GOVERNMENT OF THE DISTRICT OF COLUMBIA
OFFICE OF PLANNING

TO: Board of Zoning Adjustment

SUBJECT: BZA Application 16843

SUMMARY RECOMMENDATION
The Office of Planning recommends denial of both variances.

Exhibit 2

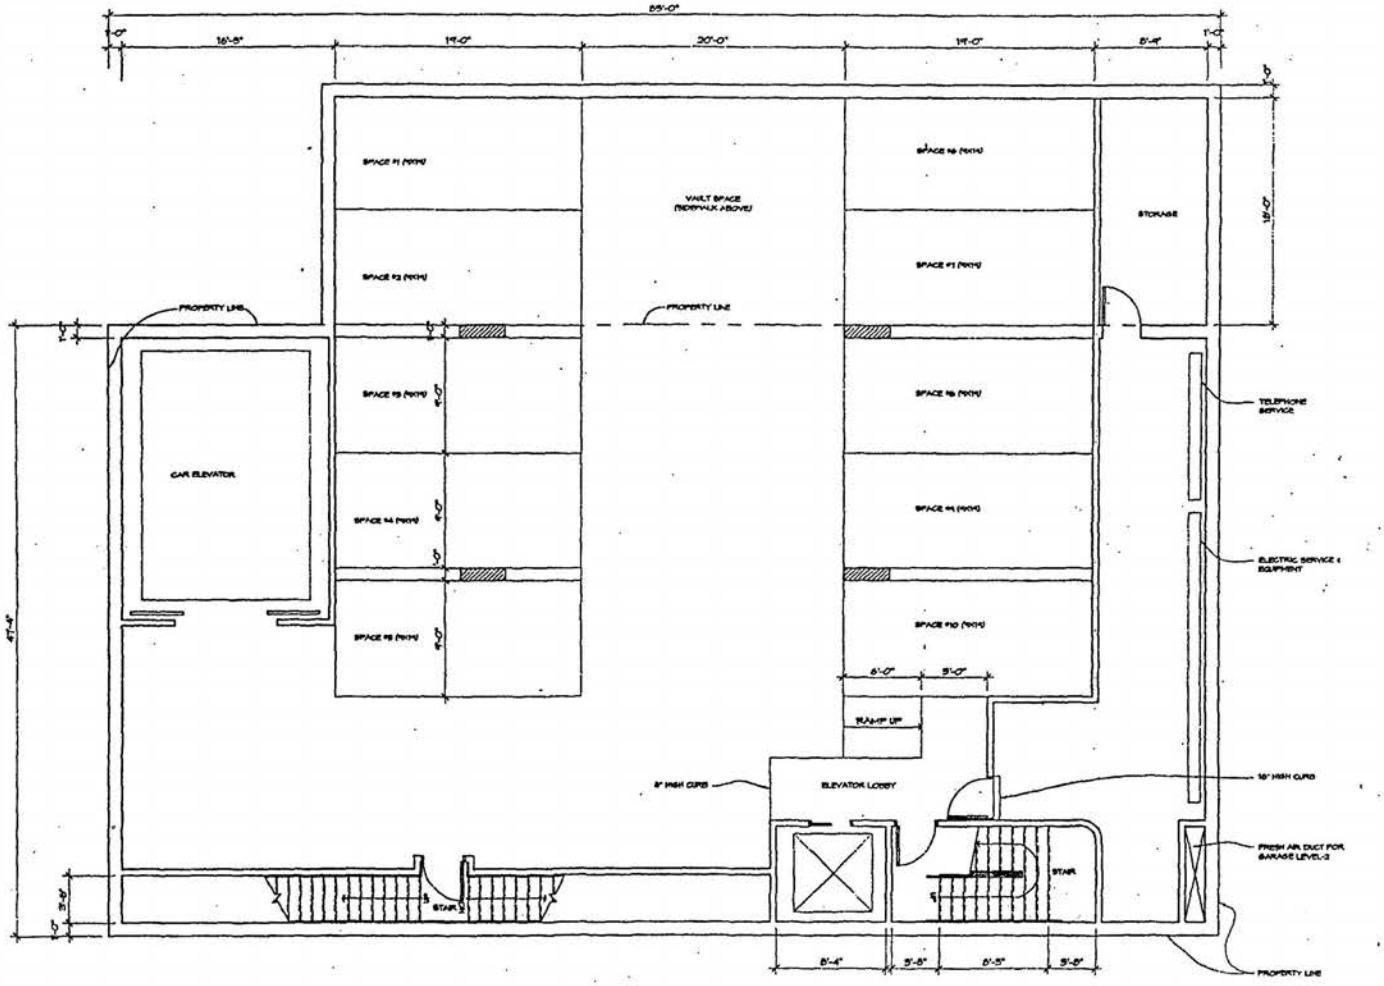
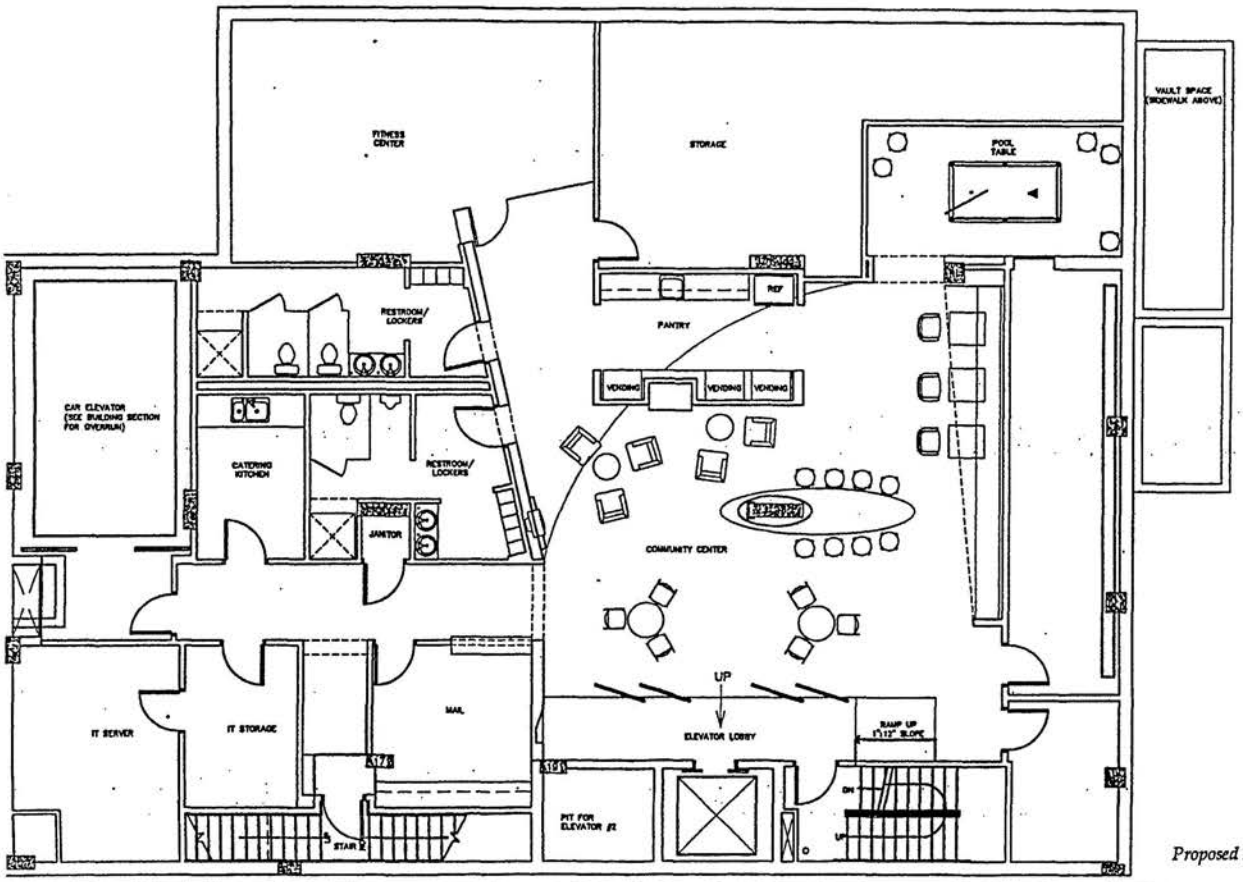
The Foundation also wishes to: convert the upper garage level into an employee lounge, mailroom, storage, and a catering kitchen; and maximize the lower garage level by parking vehicles in the travel aisles (refer to Exhibits 2 & 3). To accomplish these ends, the subject application was submitted. A Foundation representative indicated that there is a reduced need for parking because:

Based on this testimony, the BZA approval was based on the provision of twenty total parking spaces. It also established a new on-site parking requirement of twelve parking spaces. Since twelve parking spaces exist on the subject property, and vaults for eight spaces exist in public space, meeting the Final Order parking requirement does not now present a "practical difficulty". In addition:

- It is unclear why the employee lounge, mailroom, storage space, and a catering kitchen cannot be accommodated on the upper floors. The Foundation indicated that floors 2 & 3 are to be leased. Therefore, parts of these floors could be used for the mailroom, etc., and the 9th floor for the catering kitchen. This would put the kitchen nearer the conference facility proposed on the top floor. Staff acknowledges that the first floor area is not available for such use due to the DD requirements, however Foundation was aware of this limitation and the requirements of Final Order 16498 prior to purchasing the building and property. The Foundation representative stated that this property would be utilized regardless of the final BZA action.

Exhibit 3

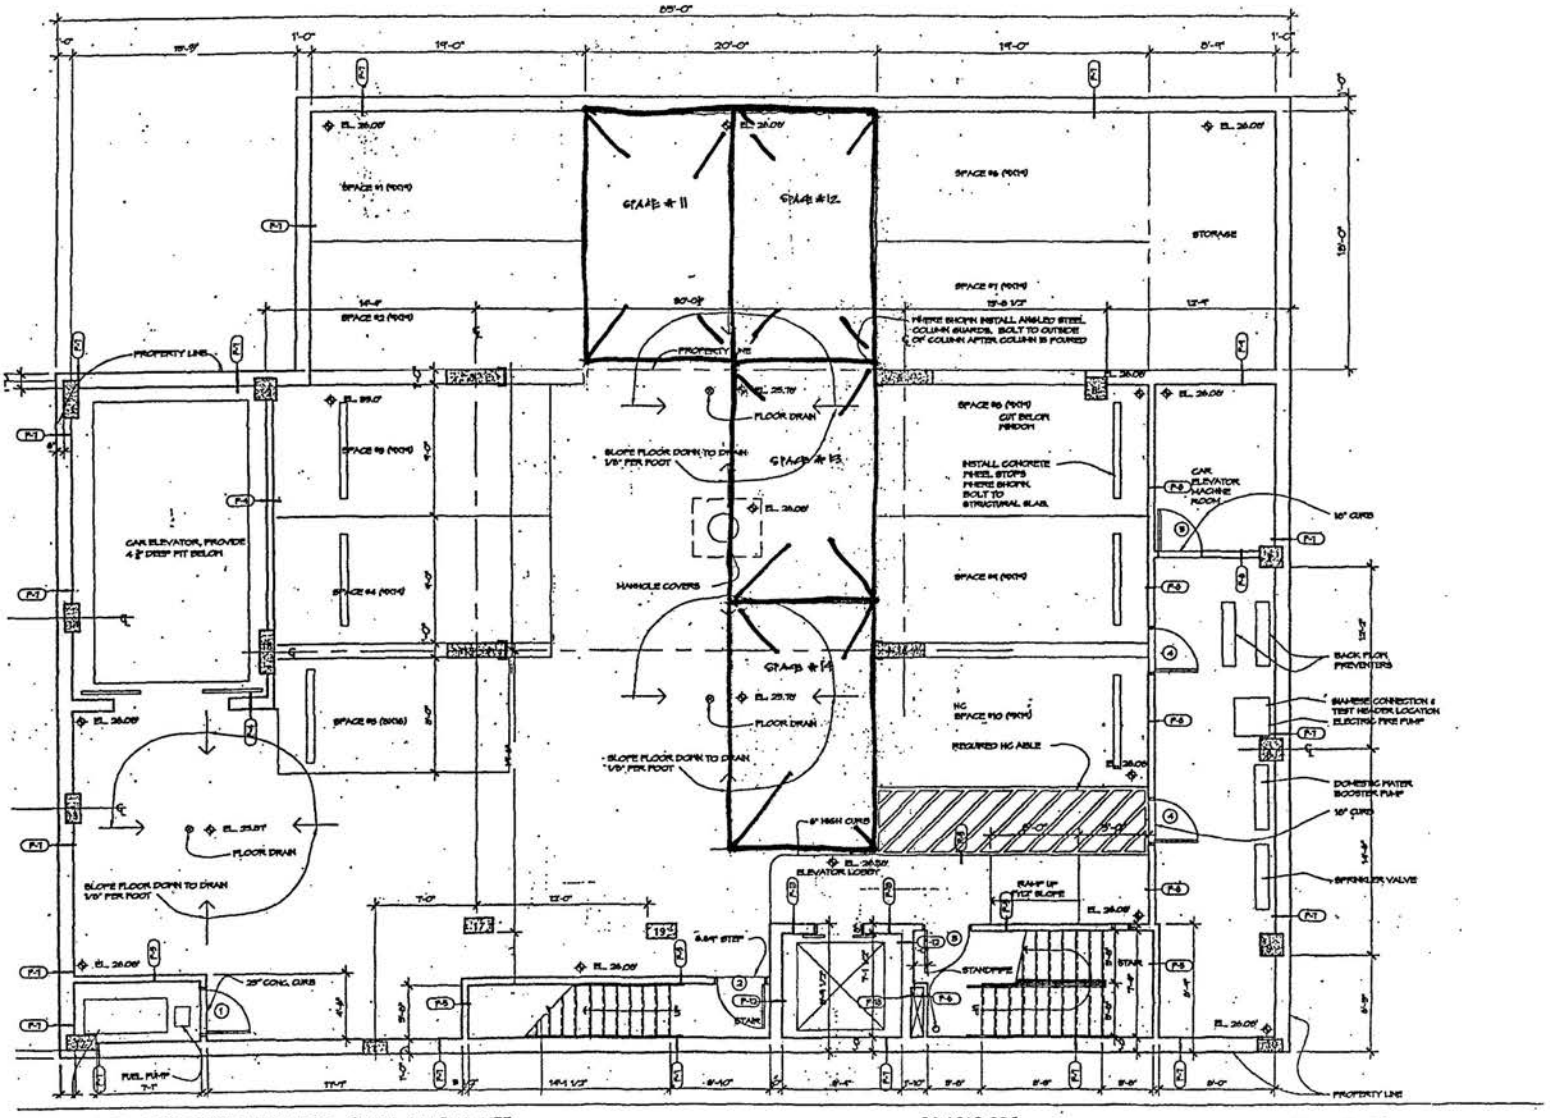
The request to use the existing drive aisles to meet a reduced parking requirement does not meet the "uniqueness" standard. The applicant also did not establish that an extraordinary condition exists whereby the drive aisles must be used to meet the parking requirement, or how meeting said requirements would result in "exceptional and undue hardship", especially since the building has been built with the parking spaces. The aisles should be preserved to allow maximum maneuverability in very close quarters. In light of these findings, a variance from the parking lot design requirements under Section 2117 also cannot be granted because it would impair the intent, purpose and integrity of the zone map as embodied in the Zoning Regulations and Map.
